ADDENDUM NO. 2 TO BID DOCUMENTS

Date: May 27, 2025
Project: Utley Creek WRF - Lab & Operators Building
Owner: Town of Holly Springs
Engineer: Hazen and Sawyer

Utlely Creek WRF - Lab & Operators Building Project

Addendum No. 2

DATE:	APRIL 2025
HAZEN NO.:	31407-006
CONTRACT NO.:	--
DRAWING NUMBER:	C008

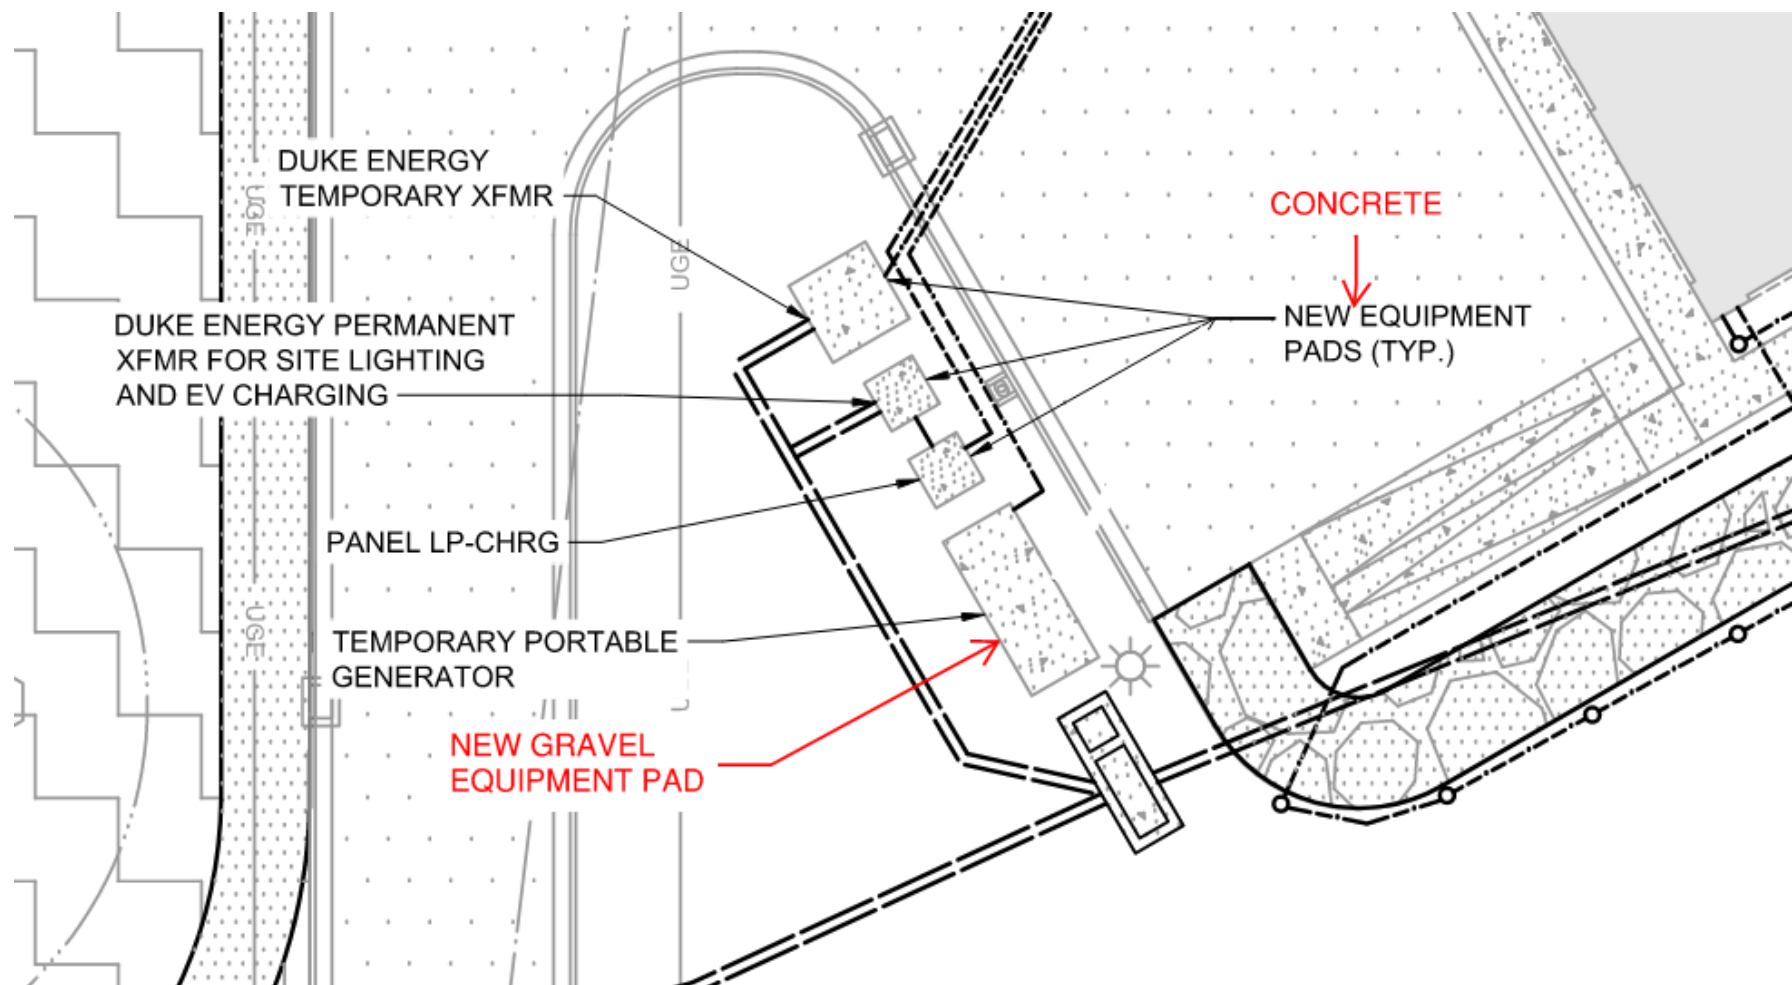
- C100 Revise Note 6 to the following: “SEE C005 FOR BOUNDARY AND PROJECT CONTROL INFORMATION.”
- C700 Revise Note 9 to the following: “REFER TO C800s FOR WATER MAIN PLAN AND PROFILES.”
- C008 See Revised Drawing C008 for updated storm and headwall structure schedules (**Attachment #3**).
- E302 Sheet E003 shall be updated as shown in **Attachment #4**.
- E303 Sheet E809 shall be updated as shown in **Attachment #5**.
